**Re: Cinnamon Morning - 2700 Rio Grande Blvd NW
Grading and Drainage Plan and Drainage Report
Engineer's Stamp dated: 3/19/2019 (G12D024)**

***Cinnamon Morning Cluster Development
(7 lots plus 1 lot)***

**Re: Cinnamon Morning - 2700 Rio Grande Blvd NW
Grading and Drainage Plan and Drainage Report
Engineer's Stamp dated: 1/16/2019 (G12D024)**

**Re: Cinnamon Morning 2700 Rio Grande Blvd NW
Engineers stamp date 3-18-19 (G12 / G024)**

*SITE DEVELOPMENT PLAN and
UTILITY PLAN for
CINNAMON MORNING CLUSTER DEVELOPMENT*

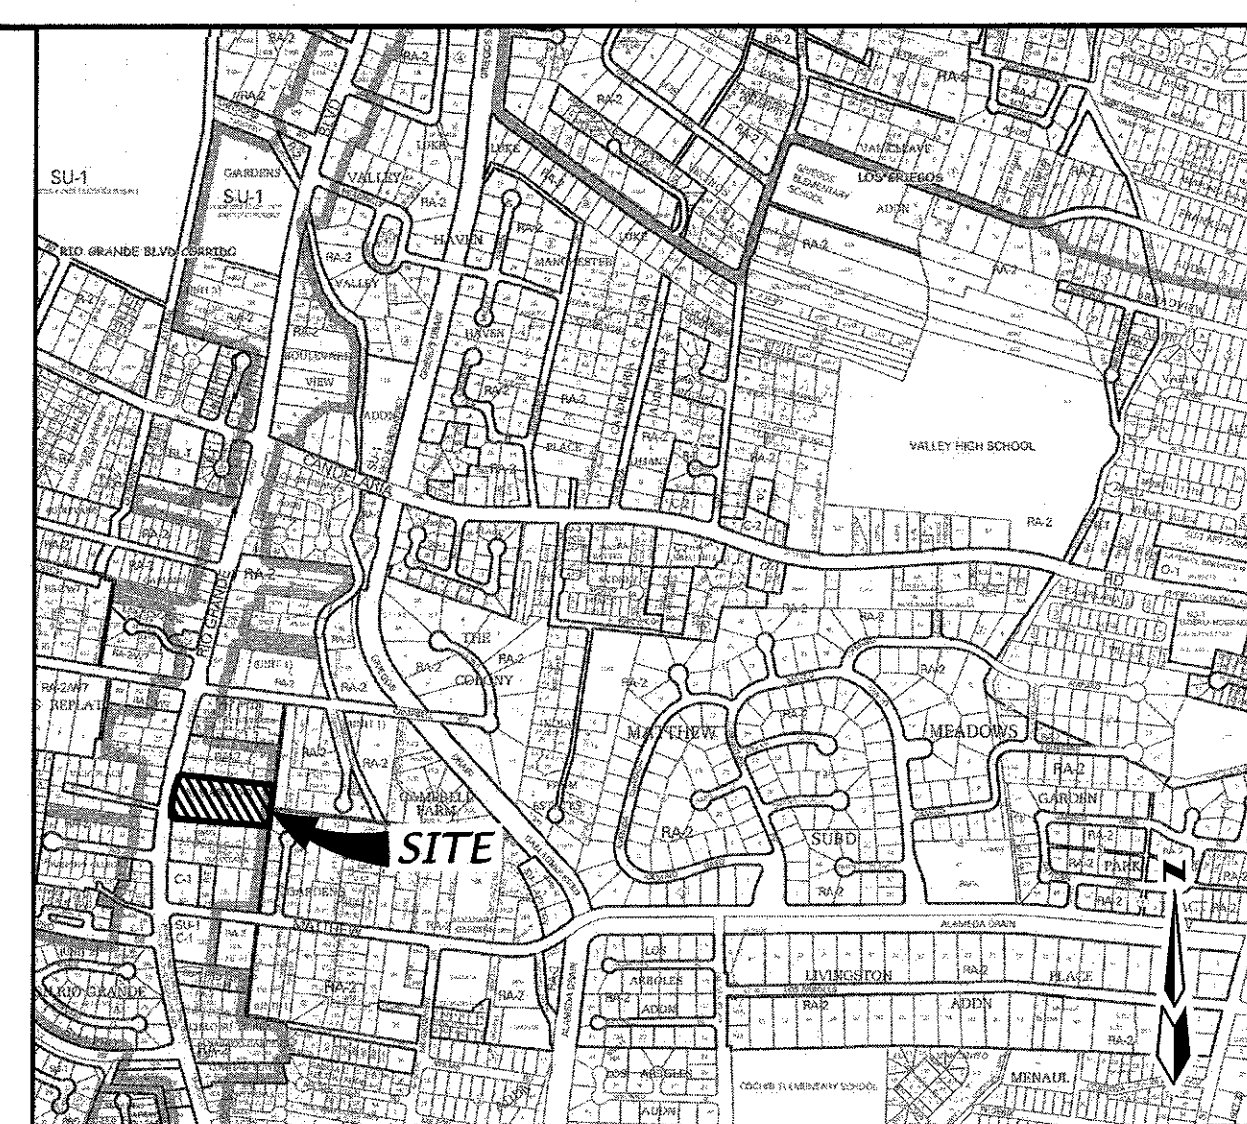
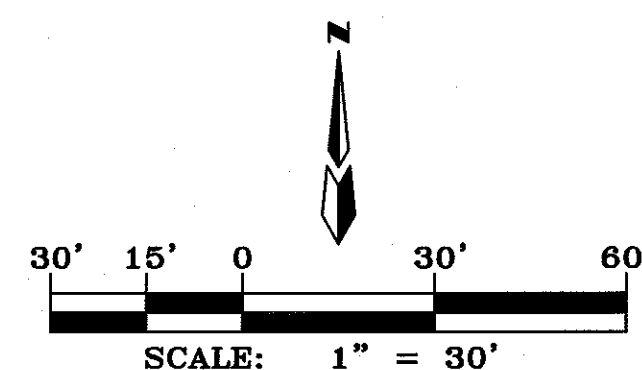
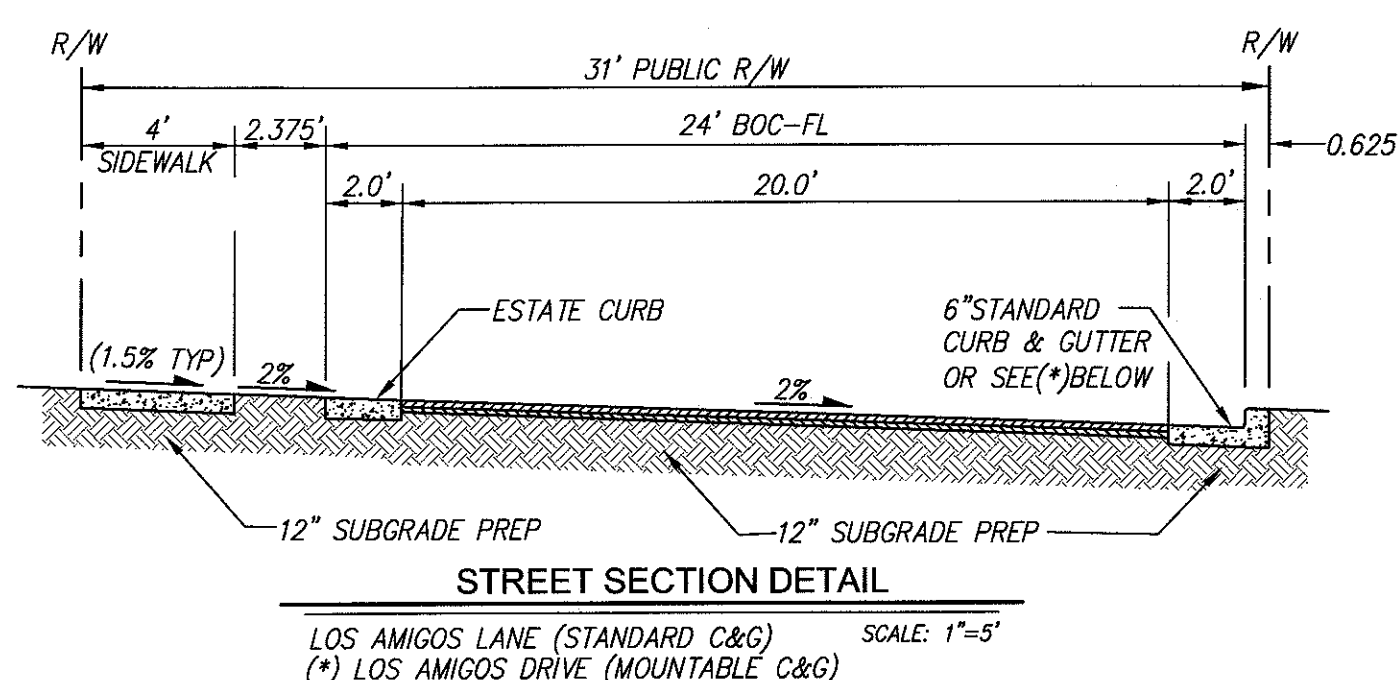
1. A block wall must be shown and labeled on both the G&D Plan and the Site Plan. Include a typical cross-section of the wall showing the proximity to the property line and the existing and proposed grades. It is still not clear where the new block wall will be constructed to prevent cross lot drainage and where the existing wall already prevents cross lot drainage. The adjacent property to the north is more than 8" higher than the finished grades onsite so the wall may need to be several courses high. Typical sections of the wall are still needed including existing and proposed grades, maximum grade change across the wall, and the offset from the footer to the property line to insure that there is not any encroachment into neighboring property. Written permission from neighbors will be required for any encroachment into neighboring property. Identify whether existing perimeter fences are to remain and where they are to be removed and replaced.

2. The hatch pattern at the edge of the pond must be identified and added to the legend. There are still not any notes on either the G&D Plan or the Site Plan to identify what the symbol represents.

1. Along the south property line there is an existing CMU wall that will remain as the property boundary. Along the east property line there is an existing wire fence. Along the north property line there is a combination of CMU stucco wall, coyote fence and wire/wood fence. Under proposed conditions, the entire north and east boundary will have at a minimum an 8" CMU filled flood wall. This will prevent any potential for cross lot drainage between adjacent properties. In the areas where there is no fencing the typical coyote fence as show on the Site Plan and Grading and Drainage Plan will be constructed. In the areas along the north boundary where there is an existing solid wall barrier, no additional wall construction is required. A special note to this affect has been added to the Site Plan and the Grading and Drainage Plan.

TITLE:
***CINNAMON MORNING CLUSTER DEVELOPMENT
GRADING & DRAINAGE PLAN***

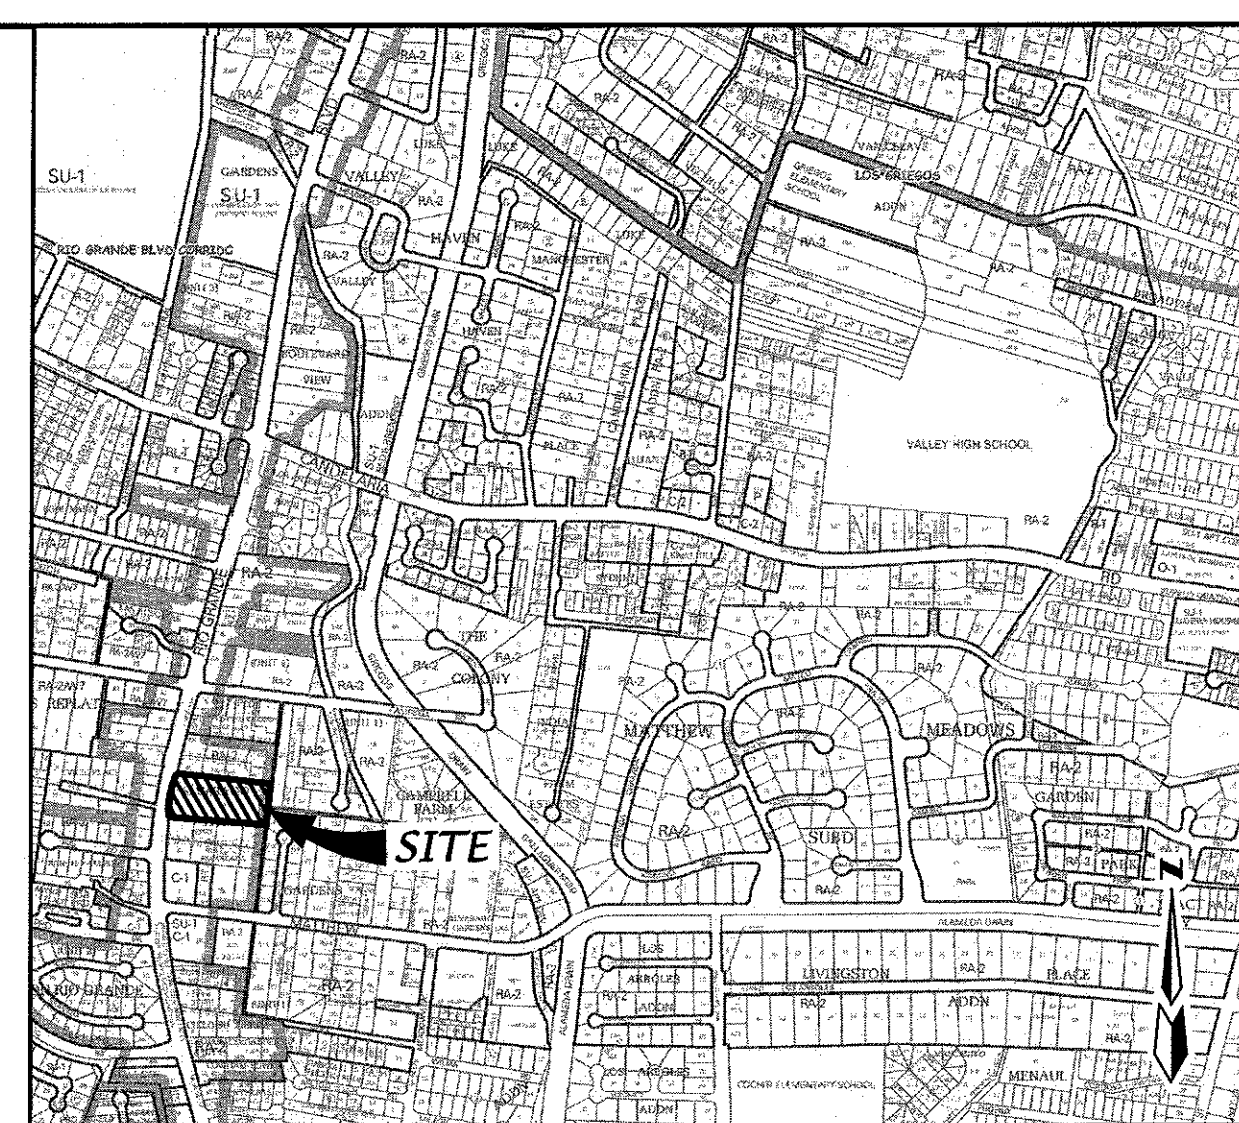
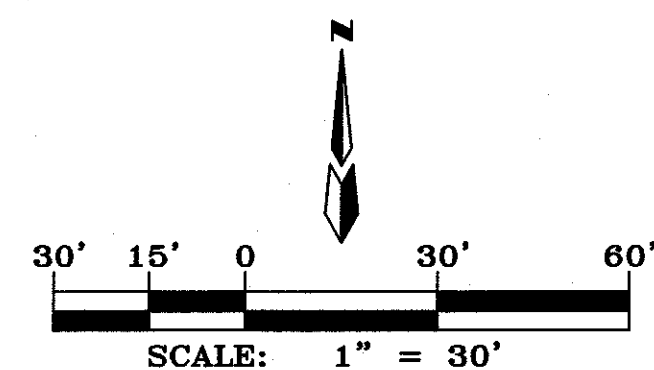
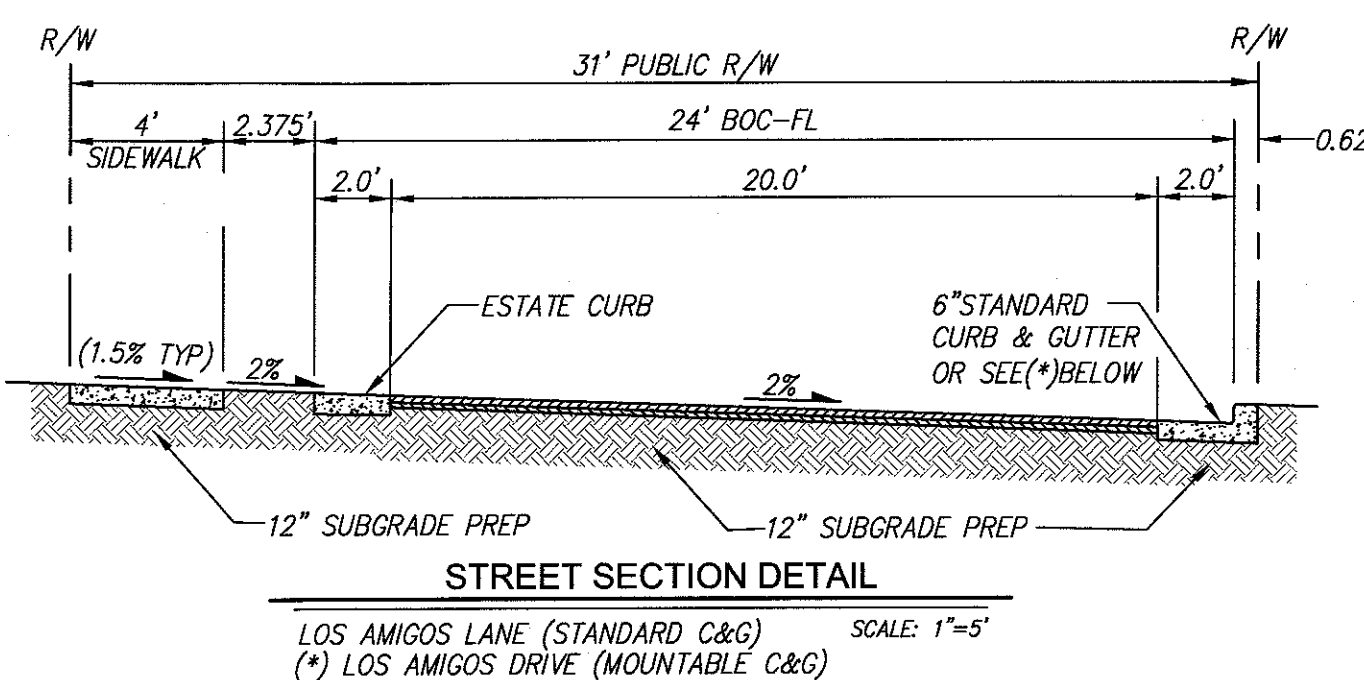
1. A block wall must be shown and labeled on both the G&D Plan and the Site Plan. Include a typical cross-section of the wall showing the proximity to the property line and the existing and proposed grades.
2. Existing spot elevations must be added on the adjacent property at each of the lot corners.
3. The hatch pattern at the edge of the pond must be identified and added to the legend.

4. The emergency spillway appears to be through Los Amigos Drive into Rio Grande Blvd. and should be sized for the peak 100 year inflow into the pond. Weir depth calculations are required on the G&D Plan to identify the emergency overflow elevation which must be lower than the Top of Pond.

2. A few additional spot elevations on the adjacent properties have been added to the grading plan. This whole area is rather flat so no additional existing spots should be necessary.

3. Okay.
4. As we discussed on the phone, it is not possible to create an overflow spillway for this project. The site has been lowered considerably in an effort to balance the required earthwork. As an alternative design, an 8" CMU concrete filled flood wall has been added to the drainage plan to prevent any offsite/onsite cross lot drainage. In addition, a 1.0 foot water block at the entrance road is created to prevent any drainage from Rio Grande Blvd from entering the site. In addition, there is almost twice the required capacity available in the retention pond.
